RE: PROJECT – 2100 CARLISLE BLVD NE CORNOR OF CARLISLE BLVD & INDIAN SCHOOL RD NE (FORMER KMART SITE) – ALBUQUERQUE, NM. 87110

ADMINISTRATIVE AMENDMENT TO SITE PLAN FOR BUILDING PERMIT

At this time, we are requesting an Administrative Amendment to the approved Site Plan for Building Permit that was approved through the Development Review Board (Project Number: 2019-002677, Application Number: SI-2019-00252) in June 2021. On August of 2021 there was an AA approved (PR-2019-002677/SI-2021-01012).

ADMINISTRATIVE AMENDMENT

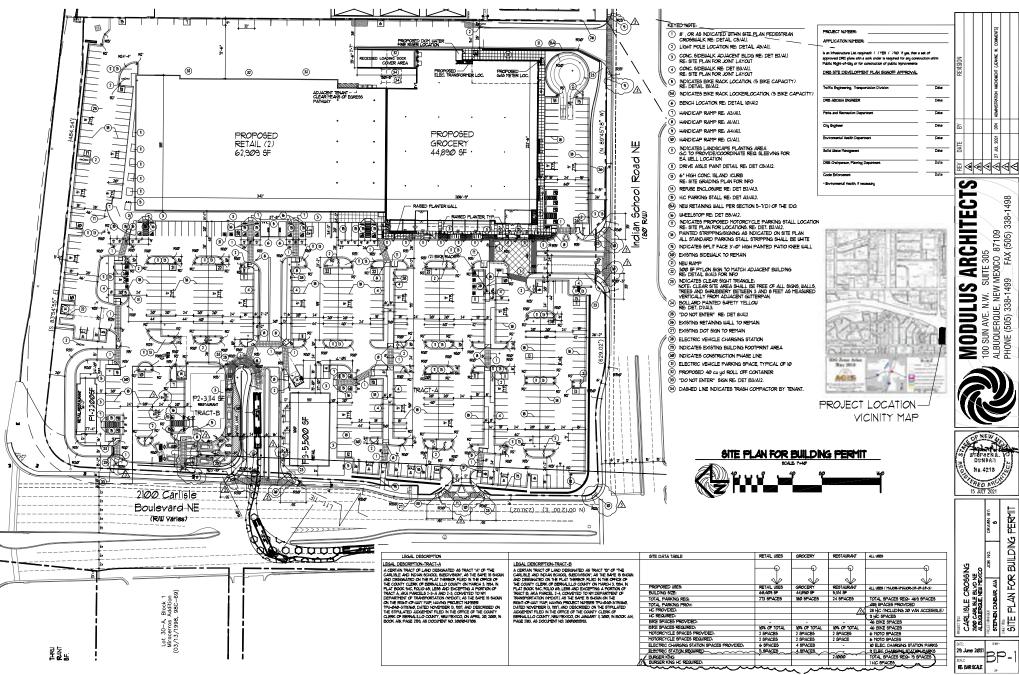
Removal of existing building pad in SE portion of site; Modification of SE corner of

parking lot into a traffic circle; Removal of (3) of (4) existing docking areas;

Modification to existing Burger King restaurant site configuration and access;

Modification of existing landscape plan to accommodate site amendments.

Landscape Plan

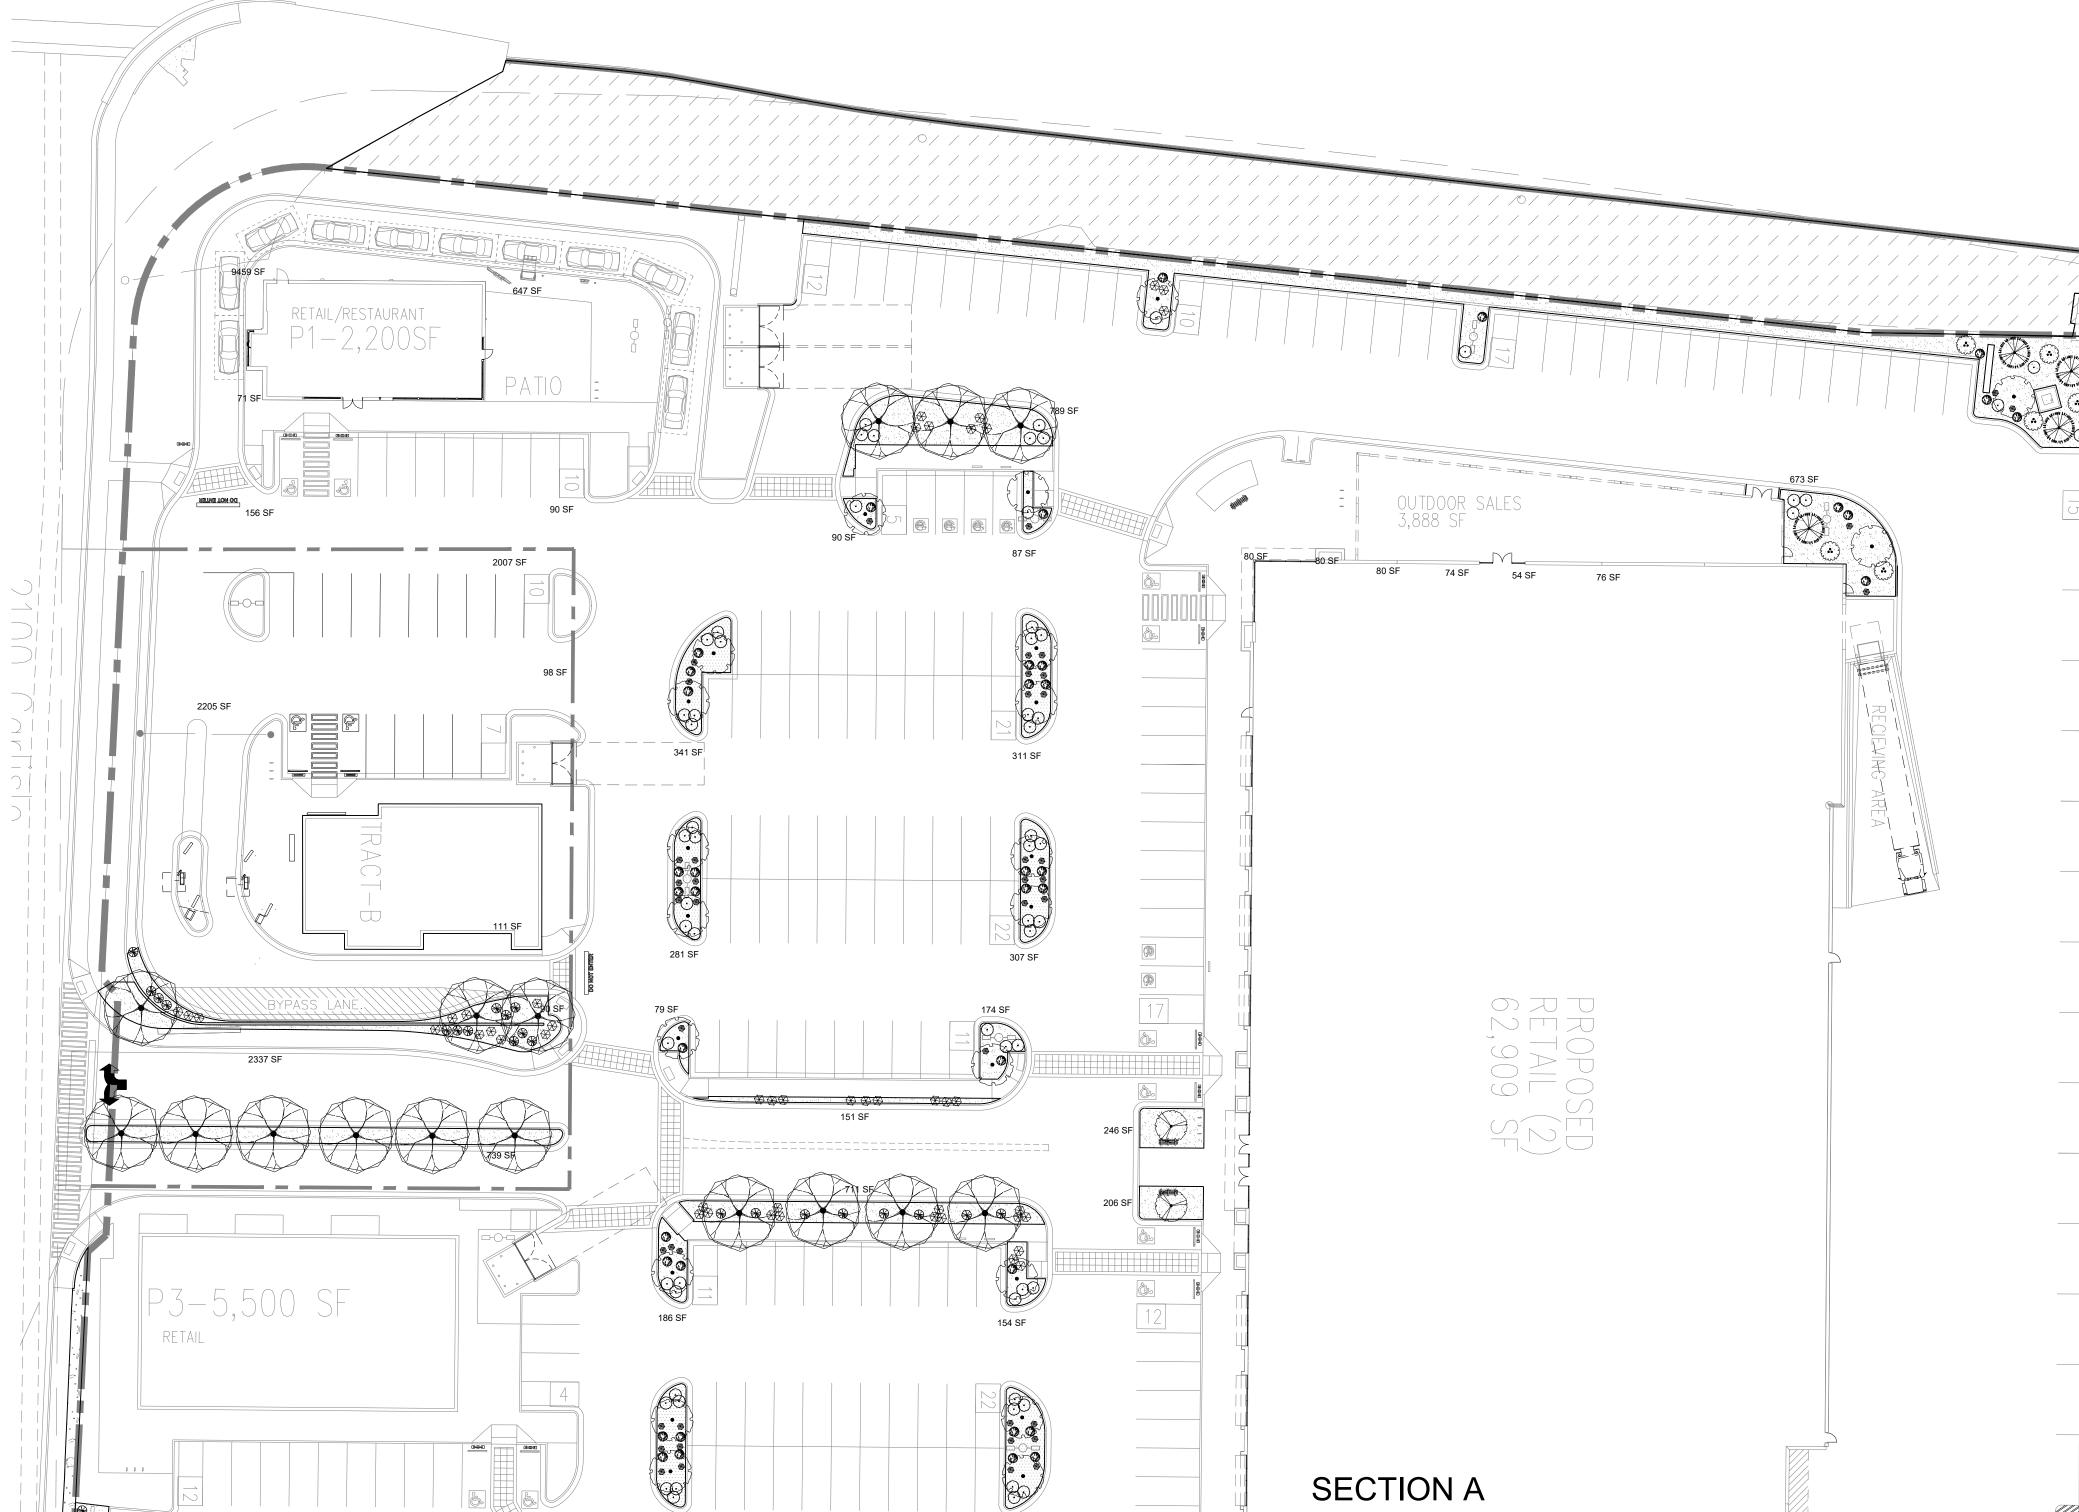
1. A Landscaping Plan has been modified to accommodate the changes to the Site Plan. All changes meet the IDO and the DPM standards. We have not created a deficiency in the landscaping requirements and that is demonstrated on the Landscaping Plan.
